CALLAWAY PLANT
DOCKET NUMBER 50-483
CORE OPERATING LIMITS REPORT
Reference: ULNRC-04145, dated November 4, 1999

CALLAWAY CYCLE 11

CORE OPERATING LIMITS REPORT

(Revision 2)

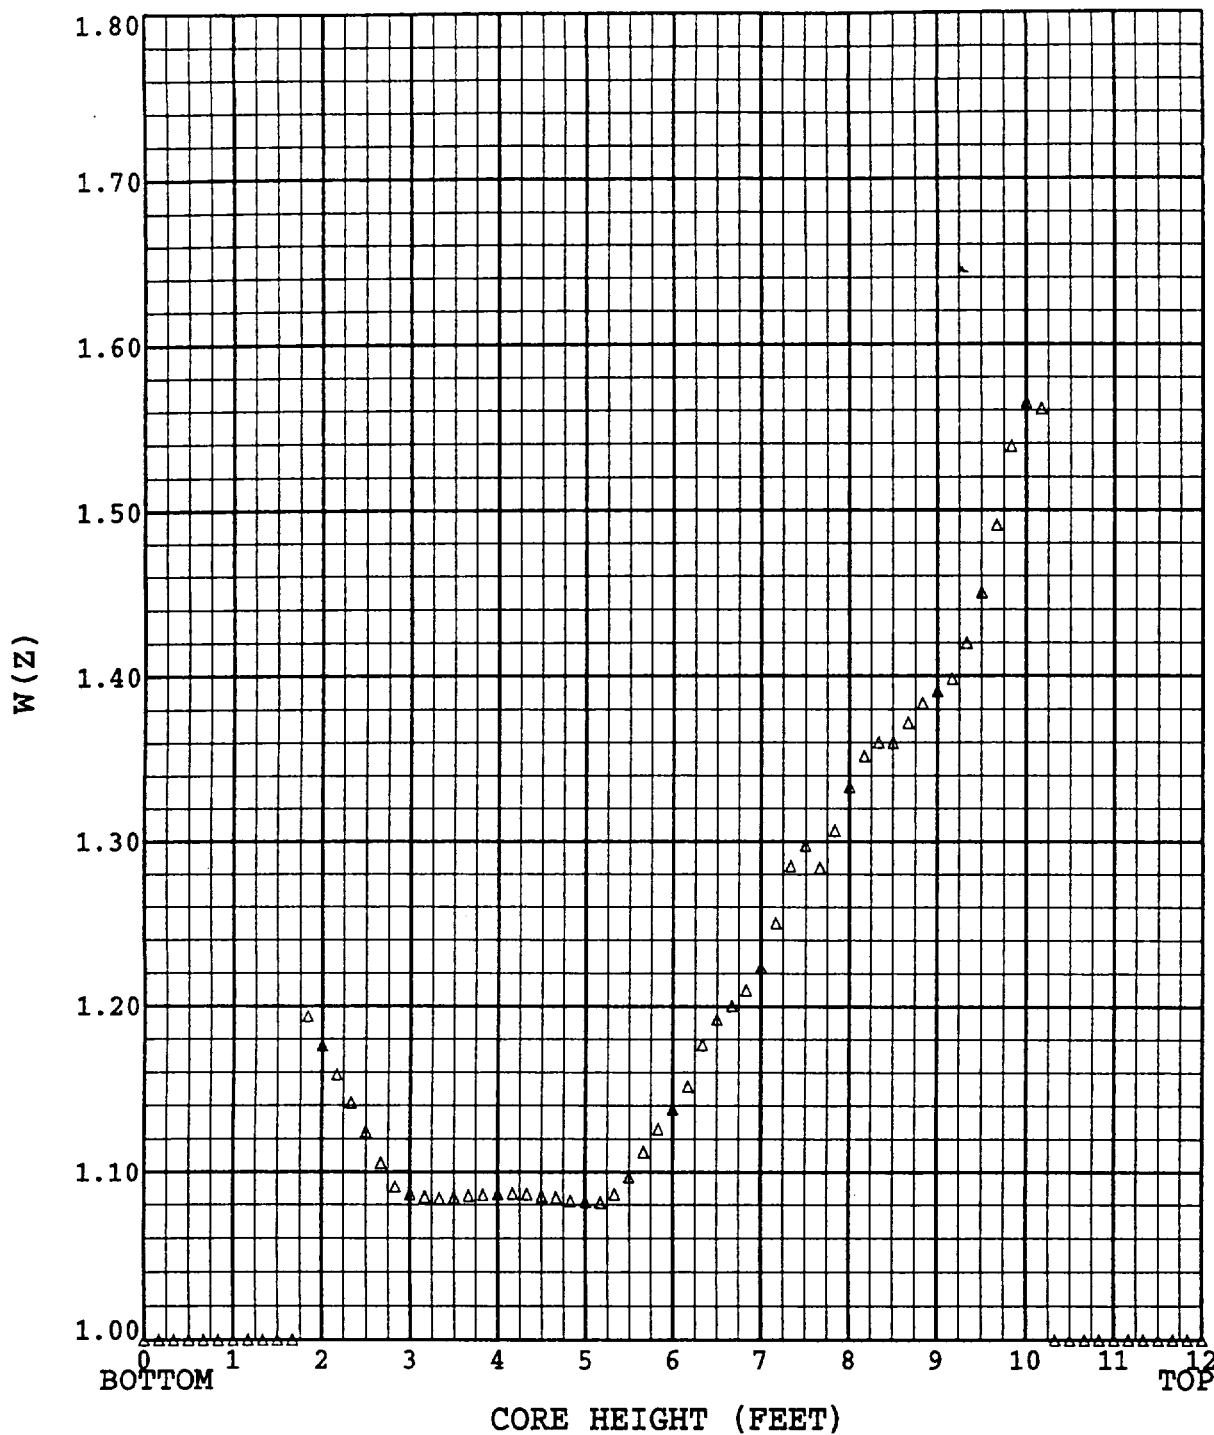
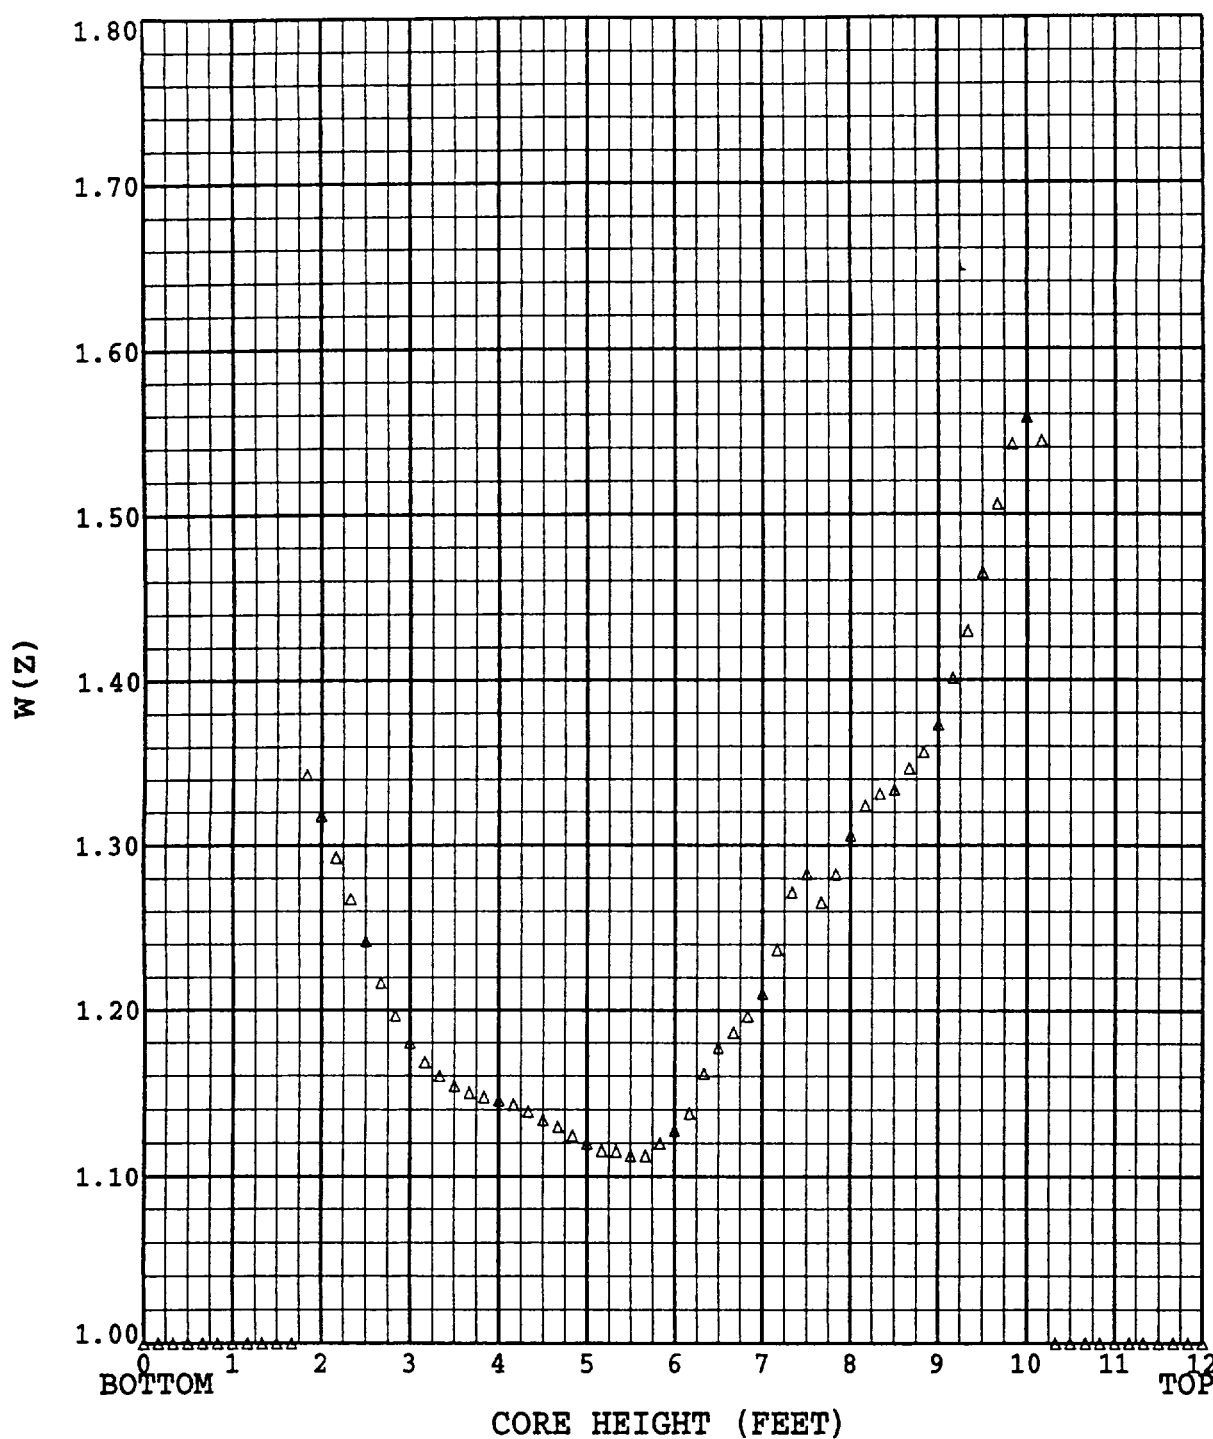
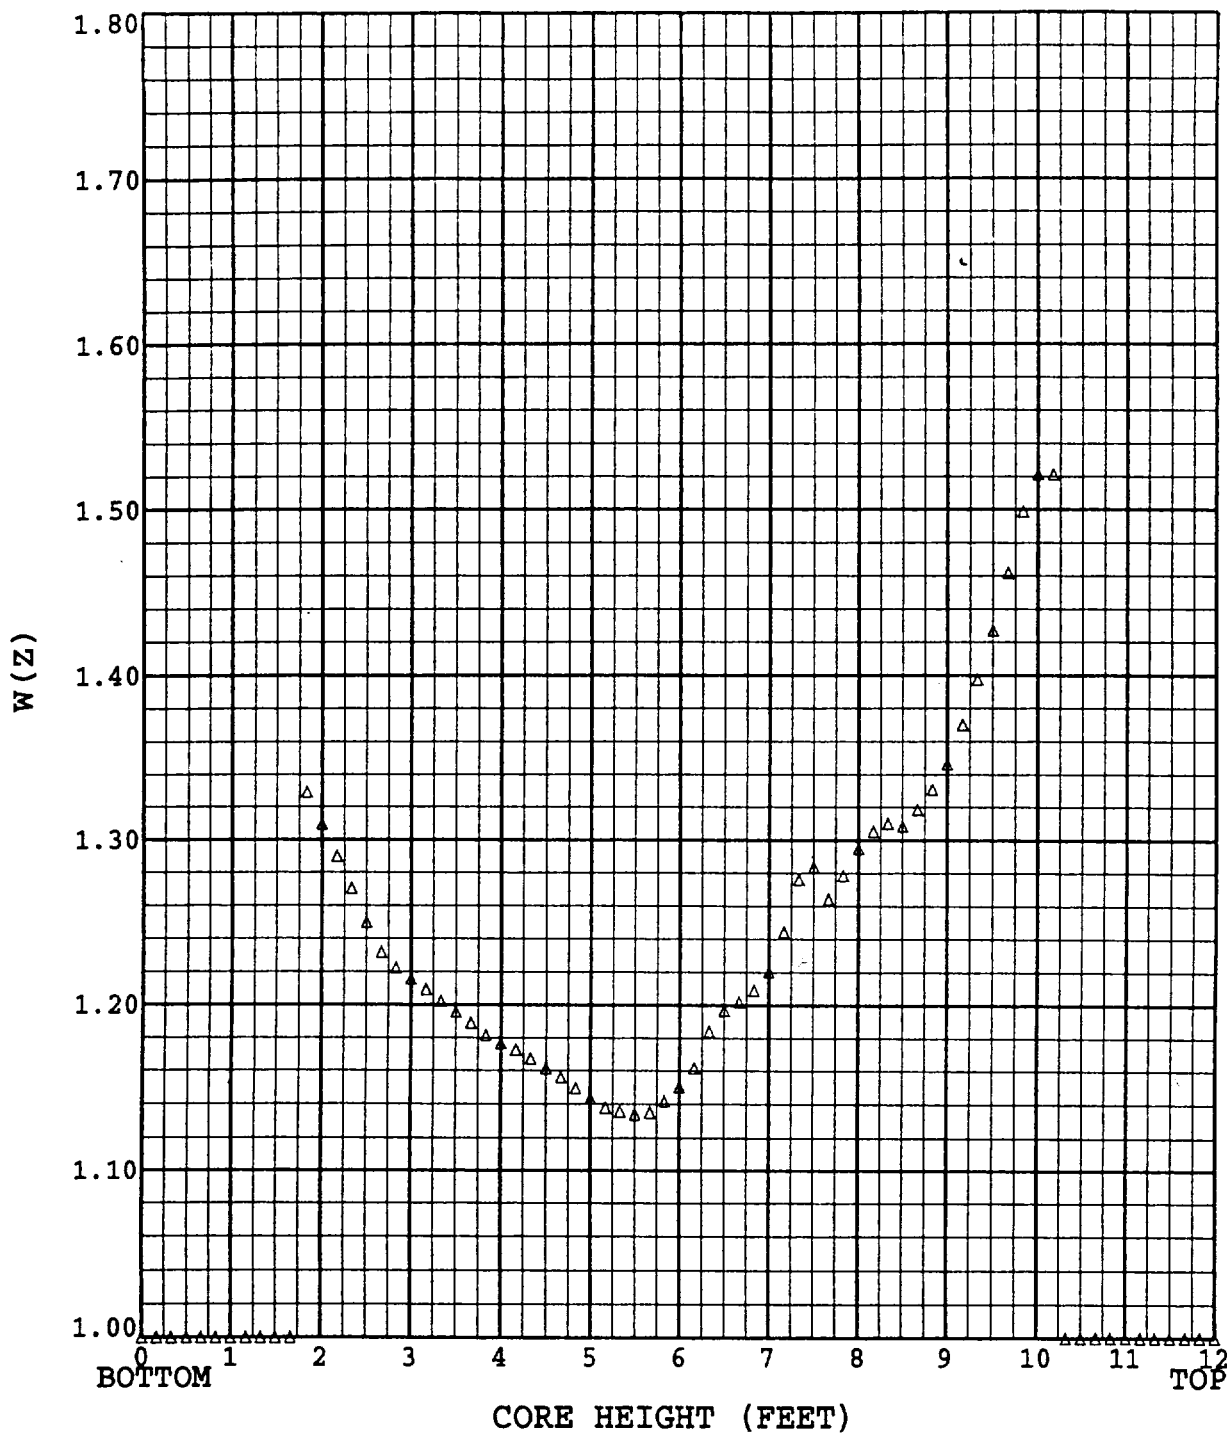
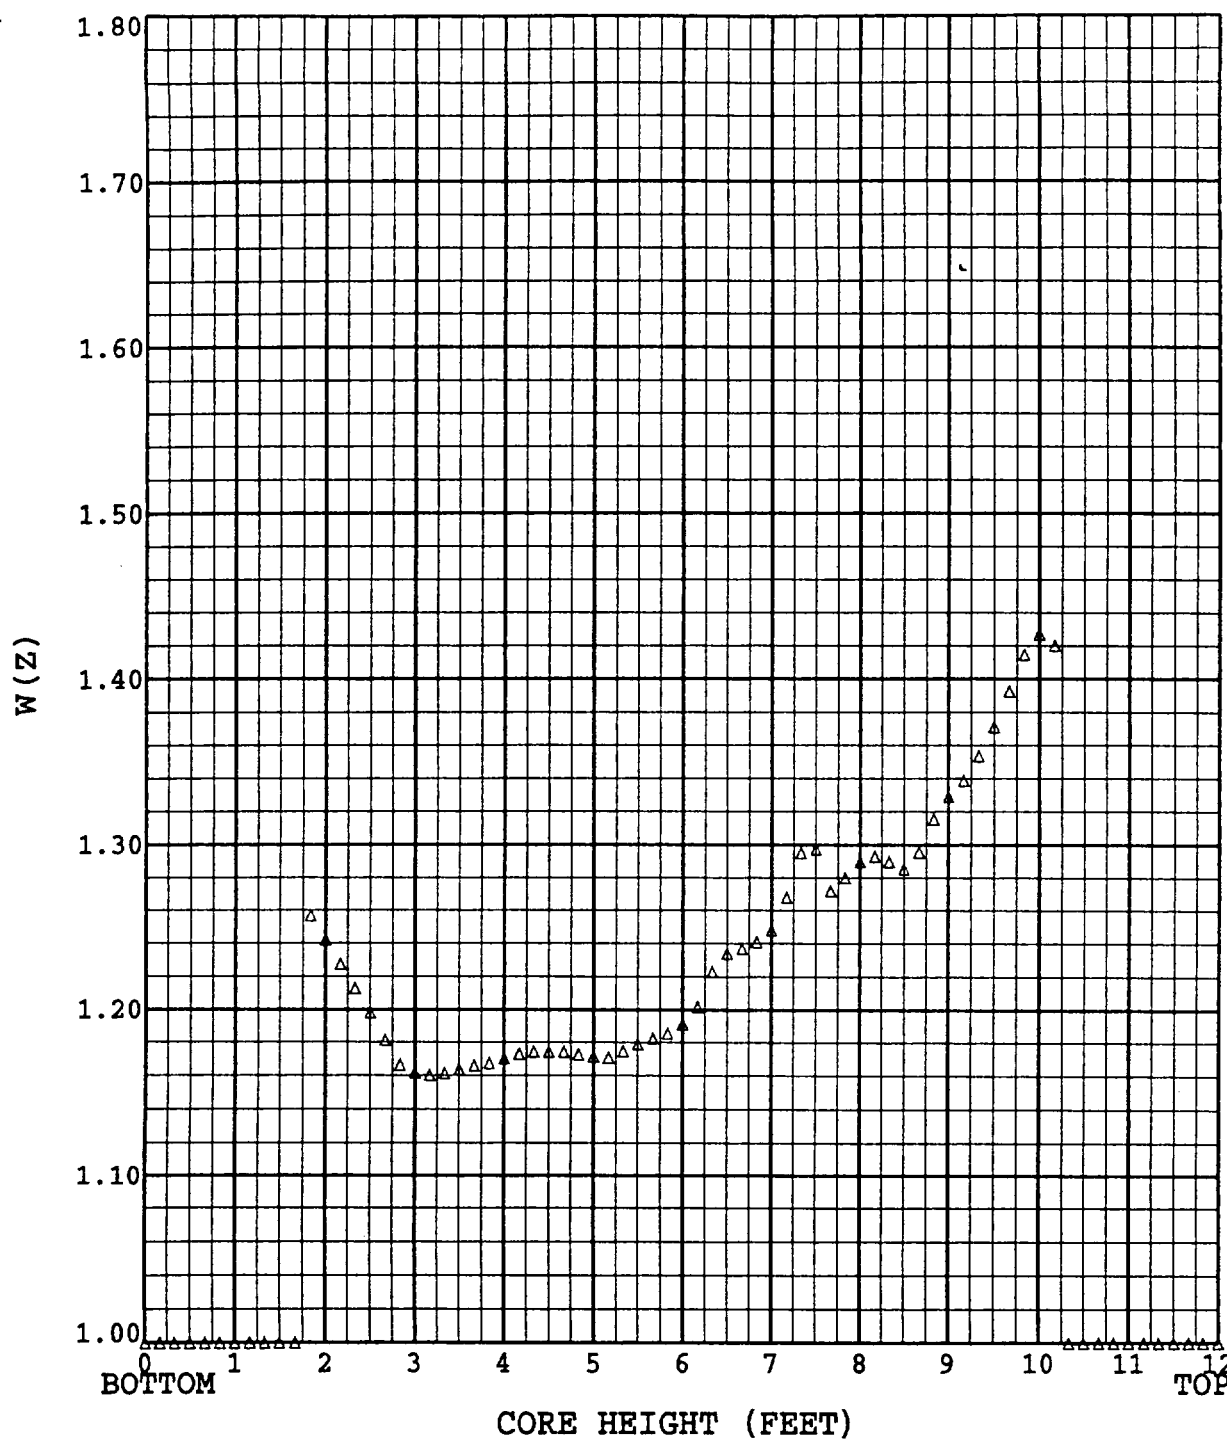
In Revision 2, the COLR has been revised in order to provide additional W(z) values. Figures 9 through 12, and Figures 13 through 16, are applicable to measured axial offsets within $\pm 3\%$ of (measured - predicted) axial offset differences of -3.9% and -9.0% , respectively. In addition, the F_Q^{RTP} limit of 2.45 for Cycle 11 is increased to 2.50 for core average burnups of 8000 MWD/MTU and greater. Revision 2 incorporates Revision 1.

$W(z)$ values have also been determined for a range of measured axial offset values for Cycle 11. For measured axial offset values within $\pm 3\%$ of the predicted axial offset value, Figures 4 through 8 are applicable. Additional $W(z)$ values are provided in Figures 9 through 12 applicable to measured axial offsets within $\pm 3\%$ of a [measured – predicted] axial offset difference of -3.9% . Figures 13 through 16 provide $W(z)$ values applicable to measured axial offsets within $\pm 3\%$ of a [measured – predicted] axial offset difference of -9.0% . For purposes of burnup interpolation, a consistent set of $W(z)$ values should be used based on the difference between measured and predicted axial offset. The $W(z)$ set selected could be either the set closest to the actual [measured – predicted] axial offset difference, or a consistent set derived by linear interpolation on the [measured – predicted] axial offset differences between two of the $W(z)$ sets closest to the actual [measured – predicted] axial offset difference.
